The Following information is based on PCB type M12565 iss.3 The layout can be applied to other versions but the instructions below may not relate.

Revision: 1	d.c. ~ daylight ltd.	Page Size: A4	d.c. ~ daylight ltd.
<h2 style="text-align: center;">QUAD 405 new non-inverting input</h2>			5 Greenacre Drive Pontprennau Cardiff CF23 8PA
8 February 2004	Drawn: K. Snook	Checked:	Tel: +44 29 20 657149 Fax: +44 29 20 657151
		Page 1 of 1

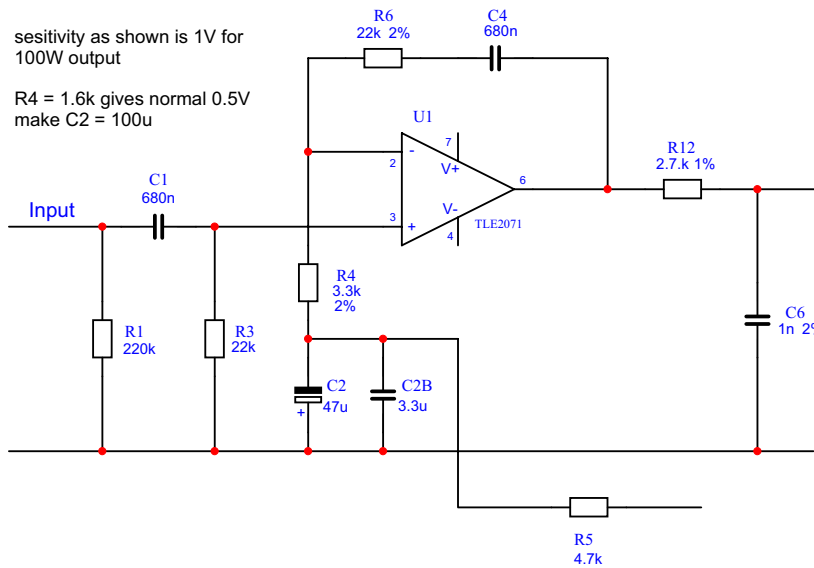
Cut track to op-amp pin 3 close to pin, remove link pins and zenner diodes D8 and D9.

Replace R10 with wire link, fit new values for R4, R6 and C4.

Fit new R3 standing upright such that it bridges R4 and fits between end of C1 and the hole to ground where the link pin was.

Fit wire link from op-amp pin 3 to junction C1/R3 this can follow a path against a ground track.

Changing R12 to 2.7k increases the frequency response to about 59kHz, this may not be suitable where the dumpers are "slowed down" in other versions of the design.
